GREAT WILSEY PARK PLOT D1 - COMMUNITY CENTRE

PLANNING STATEMENT ADDENDUM

17 MARCH 2025

Figure 2.1 – excerpt from the Proposed Site Plan, prepared by PTE Architects.

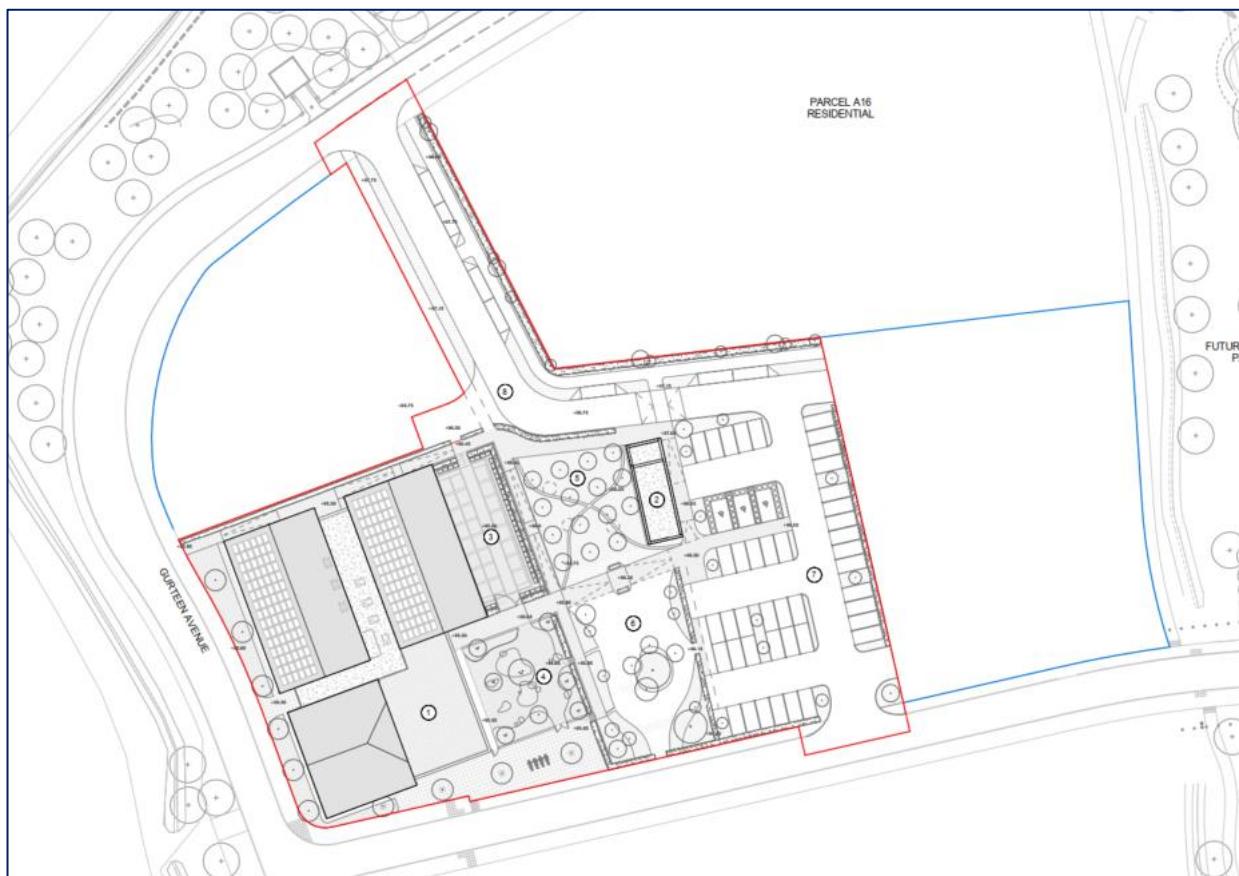
- 3.6. However, following confirmation from the ICB that the financial contribution will be accepted in lieu of the land transfer for the delivery of a healthcare facility in Plot D1, the extent of the developable area as part of this RMA is proposed to reduce from 0.93ha to 0.79ha, with the eastern boundary of the Site shifting to the west. An extract from the Proposed Site Plan is provided at Figure 2.1 below.

- 3.7. The proposed revision to the development area and the associated update to the redline boundary ensures the full 0.3 ha of land to the east of the Community Centre required to be safeguarded in accordance with Schedule 3, Clause 2 of the S106 Agreement remains free from development, whilst also ensuring that there is not an overprovision of car parking on the Site; maintaining flexibility for future development opportunities on the remaining parcels in Plot D1 in accordance with the OPP.
